SCHEMATIC — BLOCK PLAN, CONCEPT ENVELOPE

LEVEL 1 — OVERALL FLOOR PLAN (REV M)

PROJECT Hazel Green Regional Athletic Complex Trojan Horse Arena · Hazel Green area, Madison County, Alabama (site TBD, D-006)	PHASE PHASE 2	SHEET TITLE OVERALL FLOOR PLAN LEVEL 1 · BLOCK PLAN	SCALE 1" = 40'-0"	DATE October 2026	REV M	DRAWN BY Drawn by KEYSTONE (AI) for Shane Brazelton	SHEET P2-A-101
--	-------------------------	---	---------------------------------------	---------------------------------------	-----------------	---	------------------------------

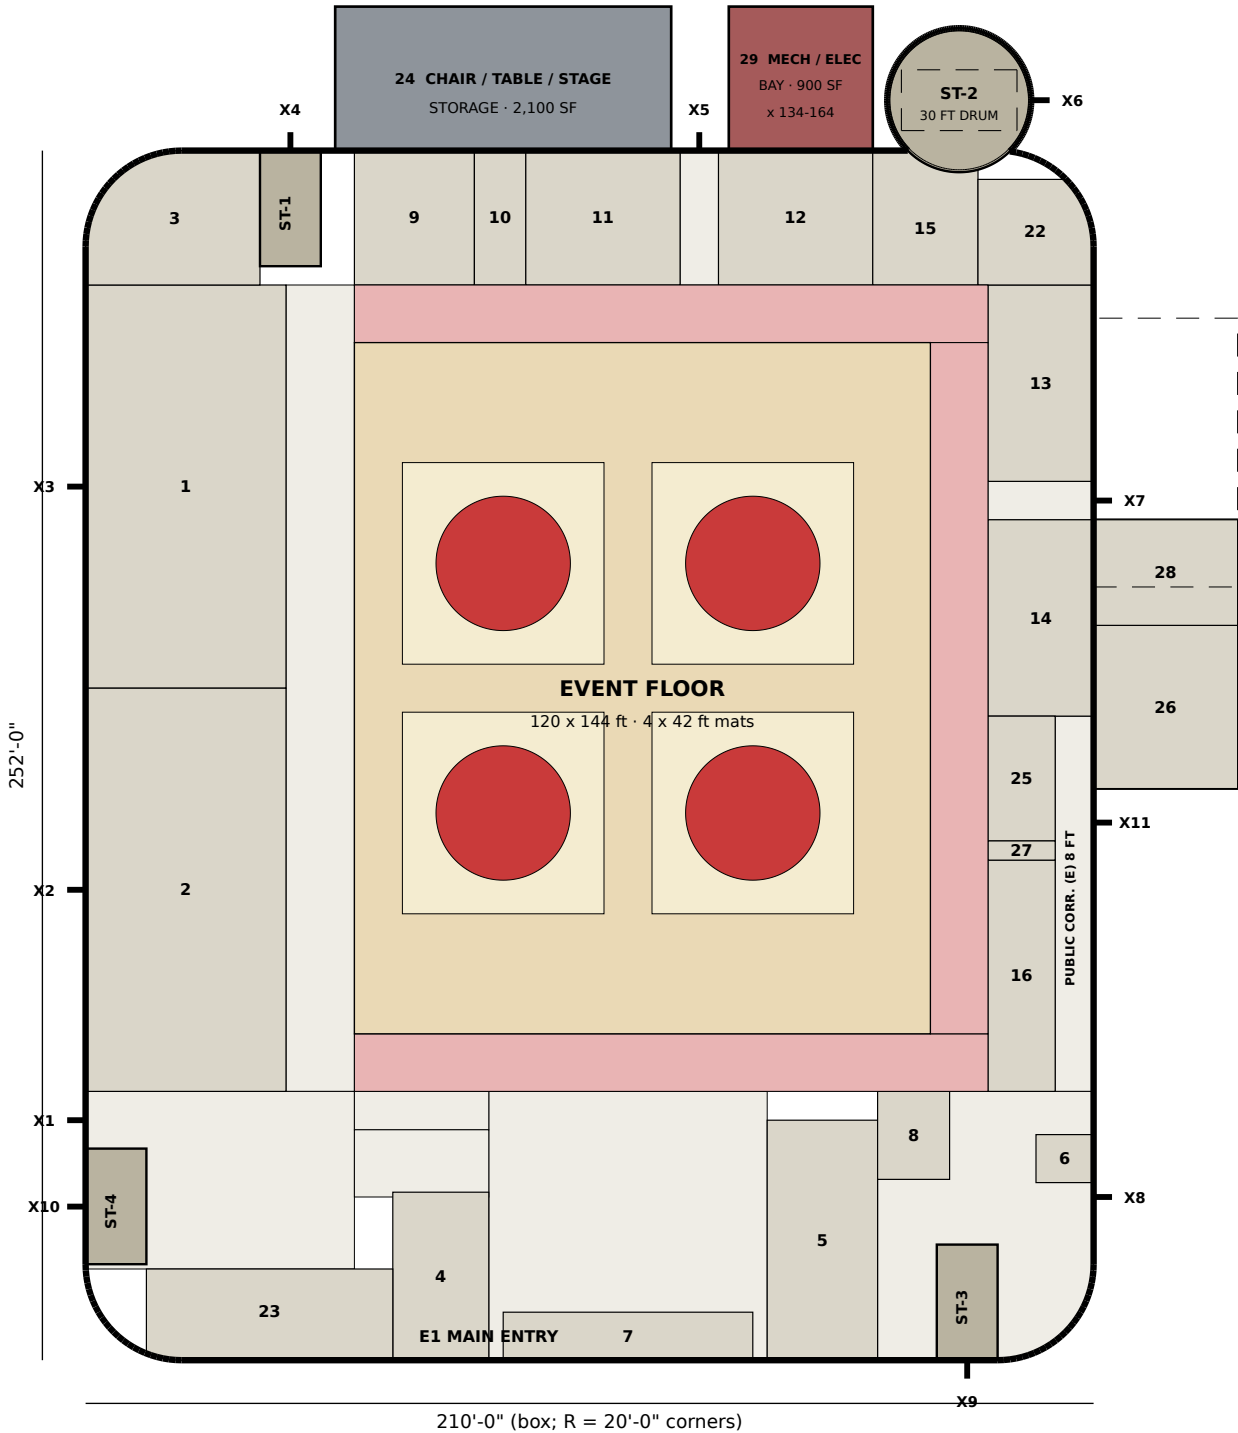
Rev L (29 ft drum, D-081) with the drum at 30 ft (D-082) and the east side back to plan Rev J (D-084 = D-072 core 2, as frozen in Set Rev D). Rev L drum and Rev L bump-out position shown dashed.

- ST-2: 30 ft drum, same centre (182, 262.5), west edge x 167. Stair fit 1.49 ft spare on the diagonal (Rev L 0.49). +35 SF on this level. X6 on the east face (197, 262.5).
- Bay stays at x 134-164: 3.0 ft to the drum; EXIT (N) at X5 keeps the 12 ft lane.
- East side = plan Rev J (D-072): core 2 bump-out 30 x 56 ft at y 119.09-175.09 (42 ft south), 8 ft PUBLIC CORRIDOR (E) x 202-210, MEN (2) 25 + DF / JAN. 27 in the old MECH (E) strip, WOMEN (2) 26 + MECH (E2) 28 in the bump-out, MECH (E) 1,720 -> 675, X7 back on the wall, new X11.

TAG	ROOM	REV L	REV M	CHANGE
15	MECH (N)	571	564	-8
16	MECH (E)	1,720	675	-1,045
25-27 Restroom pop-out block (Rev L)		1,680	0	-1,680
25	MEN (2)	0	364	+364
26	WOMEN (2)	0	1,020	+1,020
27	DF / JAN.	0	56	+56
28	MECH (E2)	0	660	+660

Net of stairs. Core 2 keeps 1,680 SF in the bump-out; the corridor (8 x 78.18 ft) and MEN (2) / DF come out of MECH (E). Old NE stair strip inside the box (about 67 SF) stays unassigned.
